**LAS VIRGENES MUNICIPAL WATER DISTRICT  
CALABASAS TANK REHABILITATION PROJECT**

**ADDENDUM NO. 1**

**April 21, 2014**

**RESPONSES TO PLAN HOLDER QUESTIONS**

**PW-131**  
1 OF 2

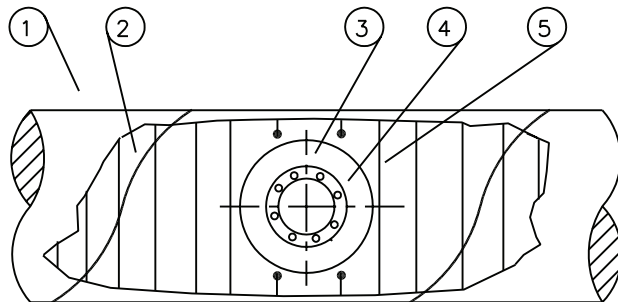
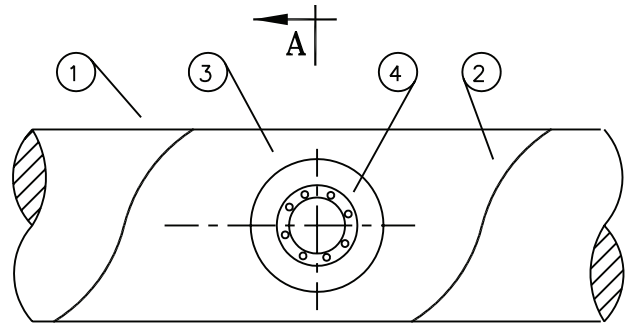
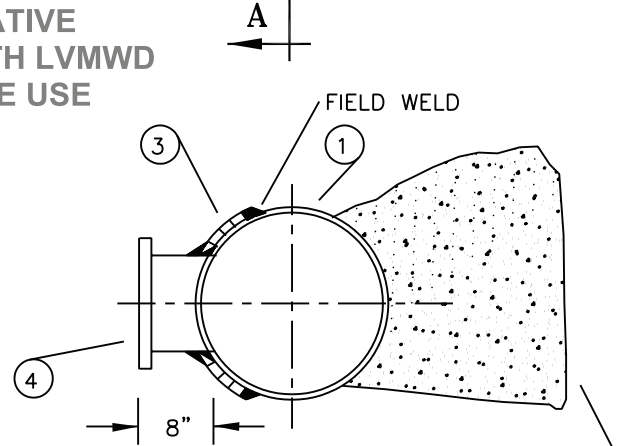
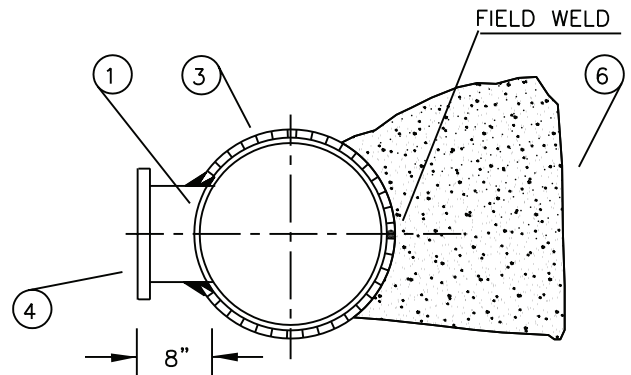
1. **Question.** Drawing Sheet 3 of 7: How to tie into the existing 16" water line? Will a tie in detail be provided?

**Answer.** Install a fire hydrant assembly, per LVMWD Standard PW-110, as indicated on the drawing. A copy of the standard detail is provided in the spec book. Tie in details are shown in Standard PW-131 (attached). Tie-in shall be performed as a hot tap.

# Gravel Bag Berm

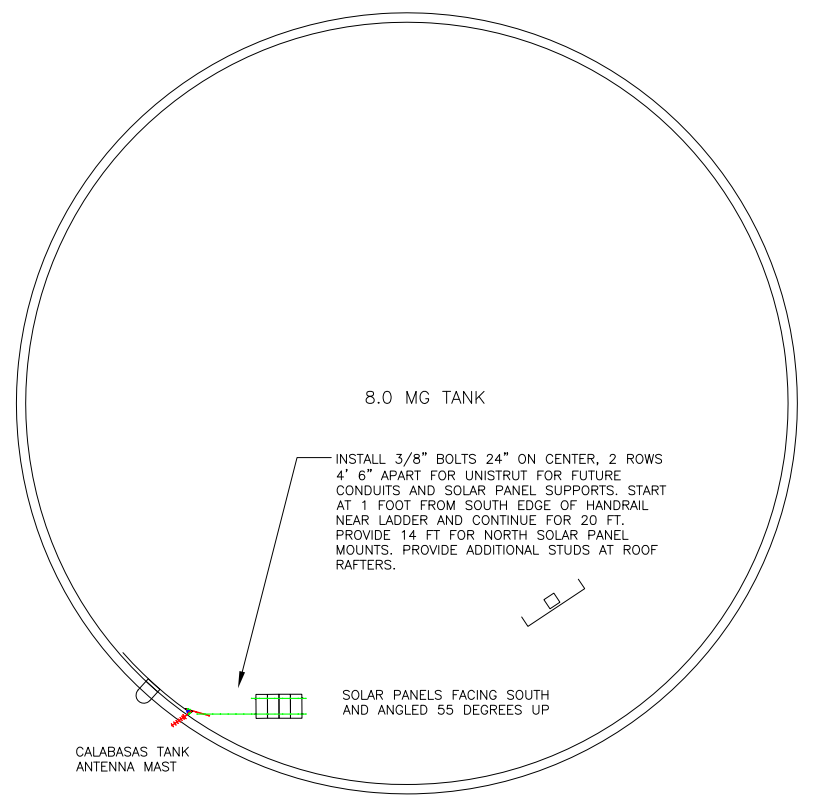
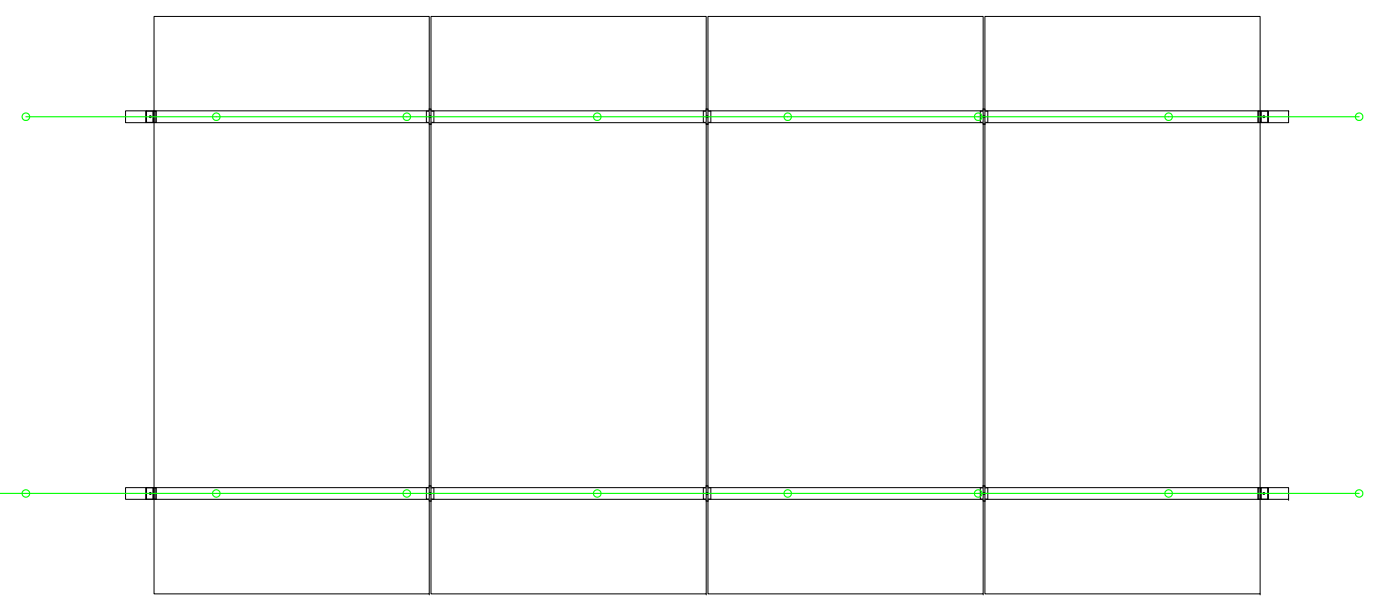
8. **Question.** Drawing Sheet 7 of 7, Gravel Berm: Please provide some direction on the gravel berm, maybe a picture of one or some publications on how to place the gravel berm?

**Answer.** Install the Gravel Berm using gravel bag shown in attached file: S-6-Gravel Bag Berm. Please refer to Drawing Sheet 7 of 7 Detail D for Gravel Berm dimensions.

SHEET 4 OF 4  
DRAWING No. 1422-010C  
JOB No. 1422  
SCALE: NONE  
UNLESS NOTED OTHERWISE BY A SPECIFIC DETAIL

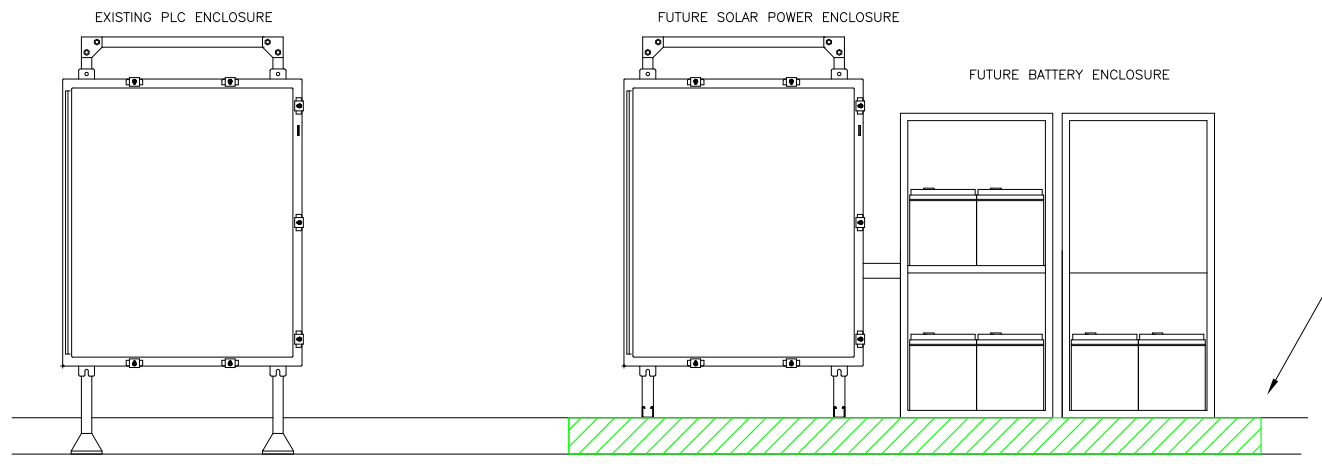
1. Drawing Sheet 4 of 7, Add No. 15 to the Scope of Contract Work as follows:

No.	Work Items	Comments /Notes
15	Install Studs For Mounting Solar Panels and Concrete Pad (24" x 96" x 6"; #5@12" at center) for New Enclosures	See Drawing No. 1422-010 C Sheet 4 of 4 "ADD STUDS FOR MOUNTING SOLAR PANELS CONCRETE PAD FOR NEW ENCLOSURES" for Details. The concrete pad shall be 24" wide, 96" long and 6" thick with #5 rebar @ 12" at center. The surface of the pad needs to match the tank's concrete base.

PROVIDE 3/8" STUDS IN TANK EXTERIOR WALL FOR FUTURE UNISTRUT TO PROVIDE ADDITIONAL SUPPORT FOR ENCLOSURES. 2 LOCATIONS NOT REQUIRED FOR BATTERY ENCLOSURES.

PROVIDE CONCRETE PAD FOR NEW SOLAR PANEL POWER ENCLOSURE AND NEW BATTERY ENCLOSURES. 24" WIDE AND 96" LONG, MATCH TO TANK CONCRETE BASE.
